THE CLOUD HOUSE AT 20 VICARS ROAD NW5 4NL: SUMMARY OF NON-MATERIAL CHANGES TO THE SCHEME SINCE ITS APPROVAL IN JULY 2020

EMILY KENNEDY & PETER MORRIS, MARCH 2021

This document collates and summarises all non-material amendments made to the scheme for The Cloud House at 20 Vicars Road, London NW5 4NL, since it was approved by the Members' Committee in July 2020, under planning application: 2020/0625/P.

4) METAL GARDEN GATES TO MATCH THE REVISED DESIGN OF THE BOUNDARY TREATMENT

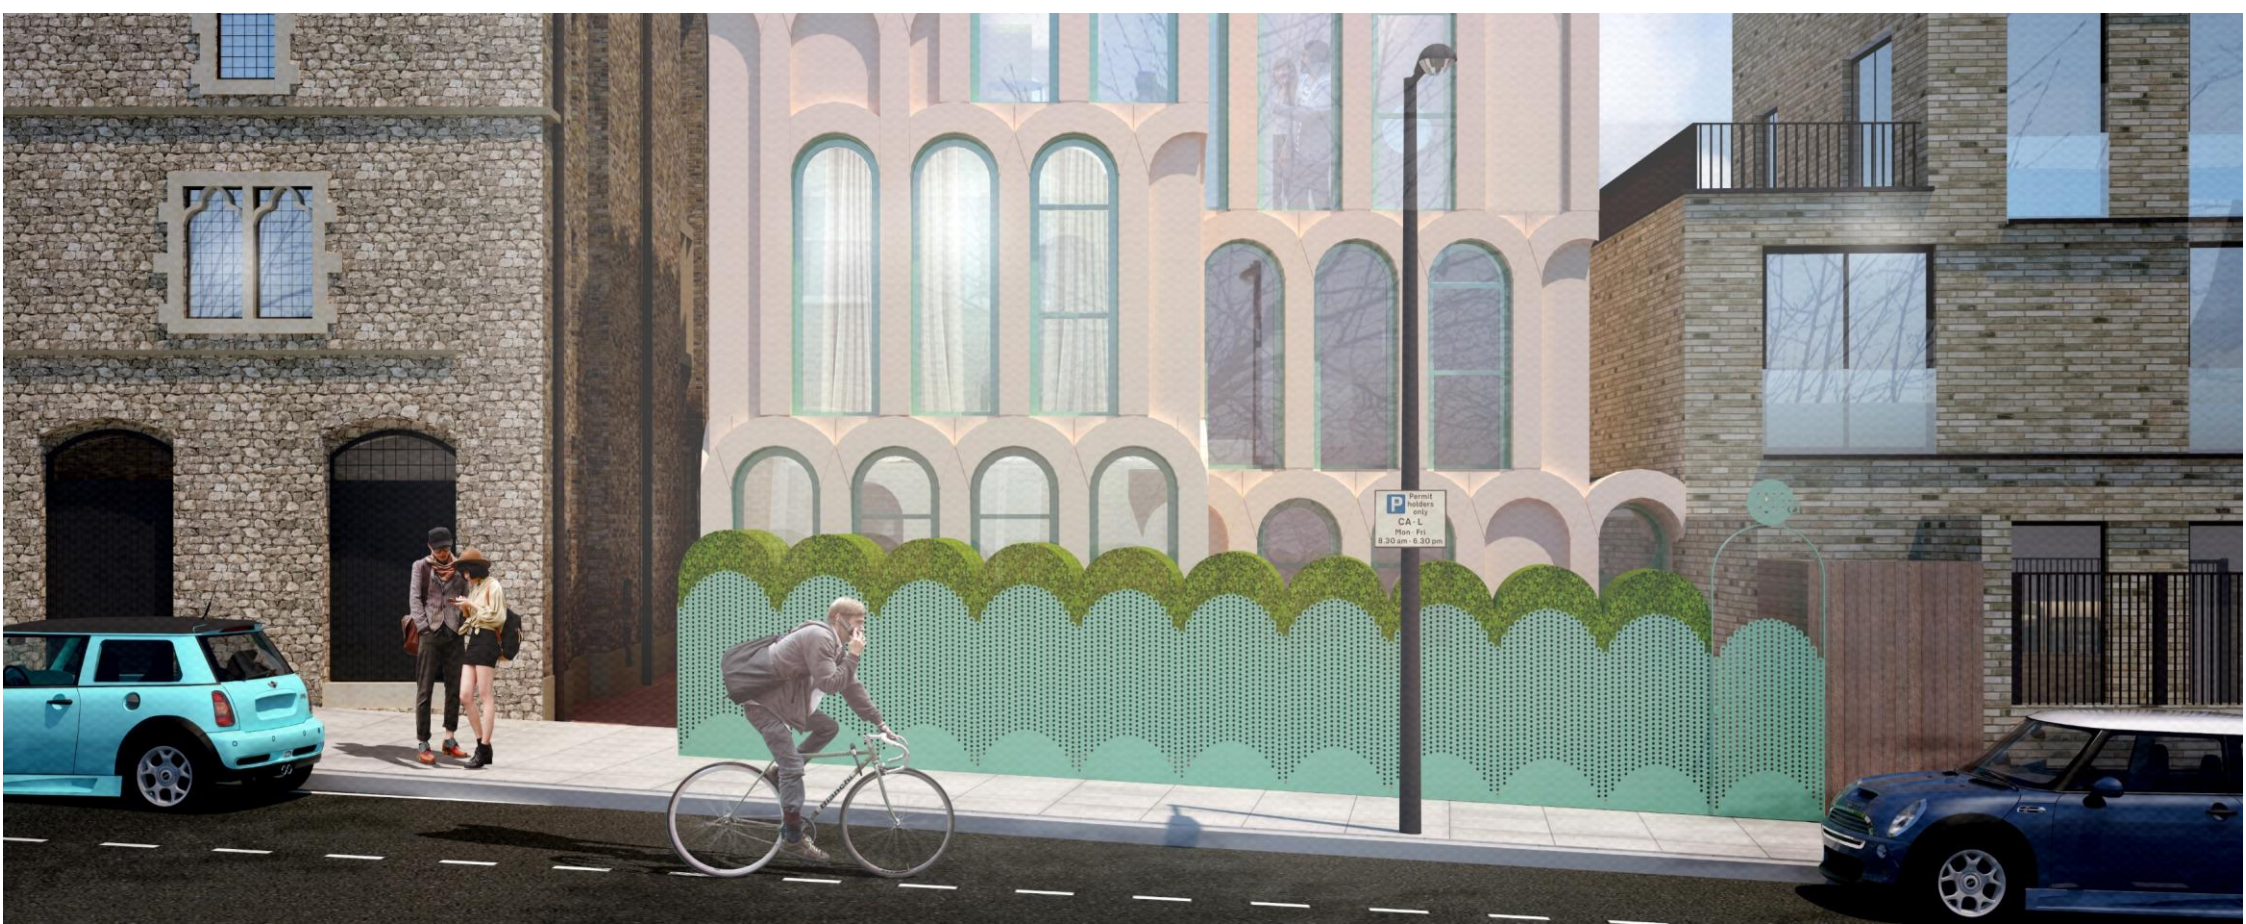
3) CHANGES TO THE BOUNDARY TREATMENT

REASON: The design of the metal boundary treatment (including the front fence, with bin and bike and heat pump storage behind) has been simplified. Following consultation with Jaspreet Chana and Colette Hatton at a meeting on 17th December 2020, and feedback on the 2nd of February 2021 on drawings submitted in January, a new scheme has been drawn up which retains the joy and colour and material of the original design, but is a little taller, and now incorporates box hedging which will be cut into topiary arches following the shape of the metal fence.

- a front fence – 115cm high at its lowest points, 160cm high at its highest points – arranged in 90cm-wide arch formations across the front of both buildings, painted in light green RAL6027, like the window frames; and also
- a series of flat-topped storage cupboards, 115cm high and 90cm deep, to sit directly behind the fence, with space for two bicycles per house, two bin spaces per house, and one air source heat pump per house; and also
- a series of planters, which will sit above the bespoke cupboards, directly behind the fence – these will be deep enough for box hedging, which will be cut into elegant arch shapes following the front line of the fence. The hedging will be dense (90cm wide, from front to back) and evergreen, bringing environmental benefit to the street, as well as looking very attractive, year round.

REASON: The design of the whole boundary treatment has been simplified, so the garden gates have been redesigned to match.

IMPACT: The new garden gates will be made from perforated powder-coated metal, with the main gate to 20A sitting within a bespoke metal arch, with a hand-crafted metal number sitting on top, lit by a bulb behind. NB No 20's main gate will match, but will be dealt with in a separate application.
